Pentium® II Processor Specification Update

Release Date: July 1998

Order Number: 243337-016

The Pentium® II processor may contain design defects or errors known as errata which may cause the product to deviate from published specifications. Current characterized errata are documented in this Specification Update.

Figure 1. UP Dual Ended Termination (DET)

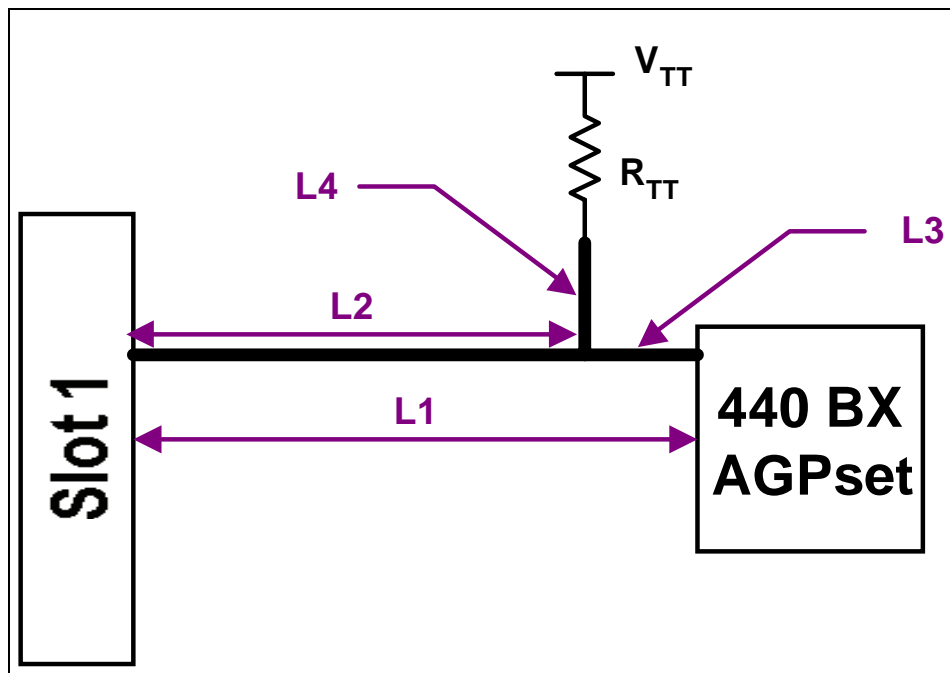
WORKAROUND: If the chipset and third party agents used with the Pentium II processor do not optimize their arbitration latency as described above, no action is required. For the 66 MHz Pentium II processor, no action is required. If agents that have implemented this optimization, by following the *100 MHz GTL+ Layout Guidelines for the Pentium® II Processor and Intel 440BX AGPset* for UP-SET (single-ended termination) and DP with both processors installed, no action is required. The following two cases are additional guidelines for UP-DET (dual-ended termination) and DP-DET with only one processor populated.

For UP-DET topologies (see Figure 1), the trace length $L1$ must be between 1.5" to 4.5" while using a 56Ω termination resistor.

Figure 1. An Example of Micro-controller Driven Thermal Management

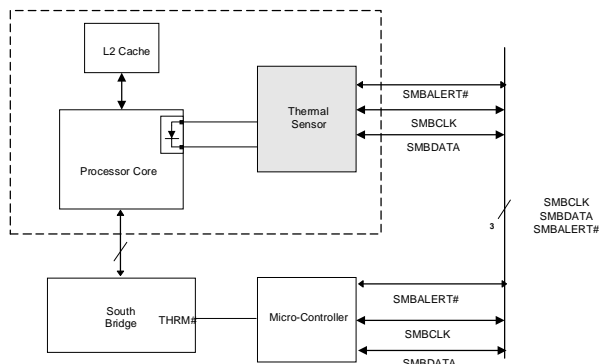
PROBLEM: The Mobile Pentium II processor and the Pentium II processor Mobile Module have a thermal sensor that monitors the processor core's temperature. Please note that desktop systems could have a similar thermal

device. The thermal sensor asserts SMBALERT# if the processor temperature exceeds the temperature limits set in the Alarm Threshold Registers (T_{HIGH} , T_{LOW}). It also sets the corresponding Status Register bits to identify the cause of the interrupt. Figure 1 gives one example of the how the SMBALERT# signal could be used in a system.

Under the conditions described below, the thermal sensor incorrectly generates the SMBALERT# interrupt. *All* of the following conditions must be met to trigger a false interrupt:

Figure 23. Processor with an Example Low Profile Heatsink Attached using Spring Clips

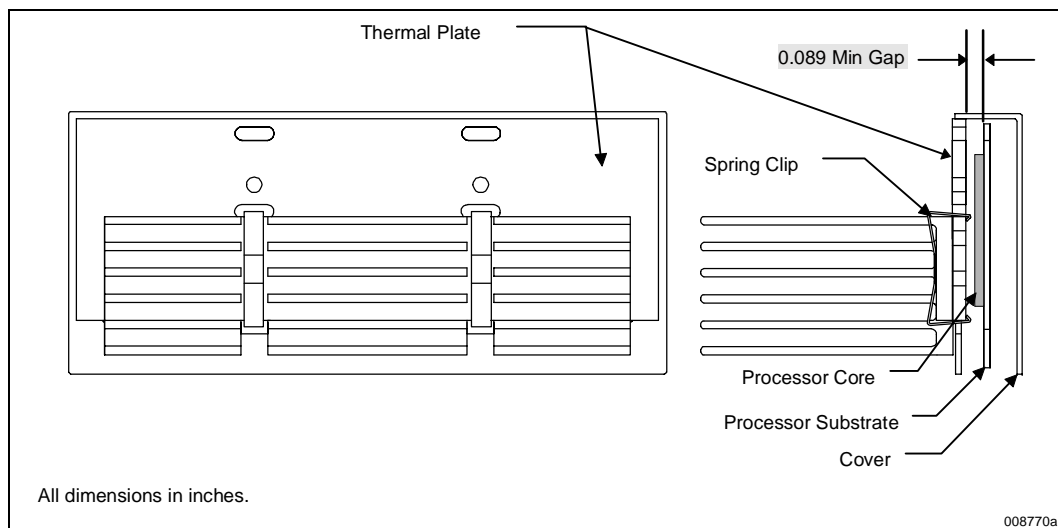
Figure 23 and Figure 24 illustrate example clip designs to support a low profile and a full height heatsink, respectively. The clips attach the heatsink by engaging with the underside of the thermal plate. The clearance of the thermal plate to the internal processor substrate is a minimum **0.089"** (illustrated in Figure 23 and Figure 24). The clips should be designed such that they will engage within this space, and also not damage the substrate upon insertion or removal. Finally, the clips should be able to retain the heatsink onto the thermal plate through a system level mechanical shock and vibration test. The clips should also apply a high enough force to spread the interface material for the spot size selected.

Figure 26. Heatsink Rivscrew* and Thermal Plate Recommendations and Guidelines

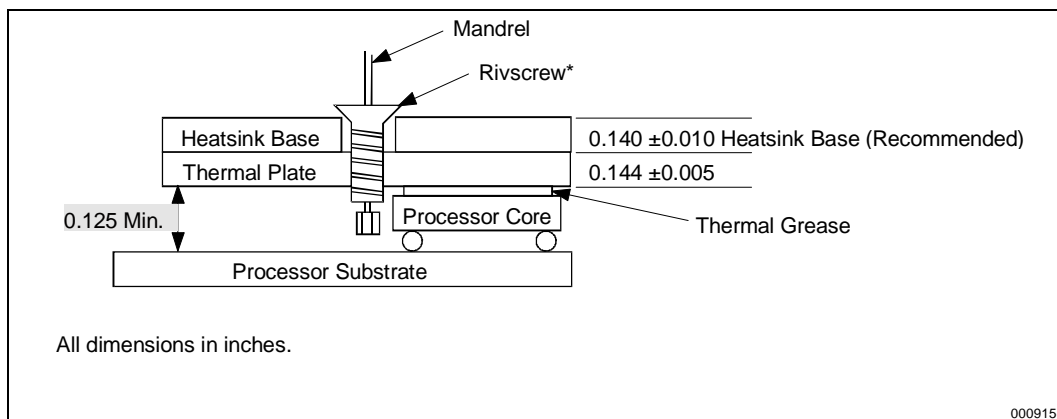
The Rivscrew attach mechanism uses a specialized rivet that is inserted through a hole in the heatsink into the thermal plate. Upon insertion, a threaded fastener is formed that can be removed if necessary. For Rivscrew attachment, the minimum gap between the thermal plate and the processor substrate is **0.125"**. For use of the Advel Rivscrew (part number 1712-3510), the heatsink base thickness must be $0.140 \pm 0.010"$. See Figure 25, Figure 26 and Figure 27 for details of heatsink requirements for use with Rivscrews.

Figure 5.6 Cross Sectional View With Vertical Dimensions

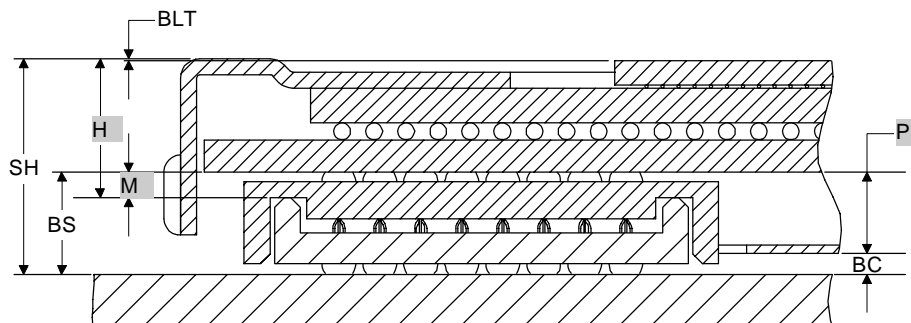
13. Misabeled Vertical Dimension Parameters

Figure 5.6 in the *Mobile Pentium® II Processor at 233 MHz and 266 MHz* datasheet should be replaced by the following figure:
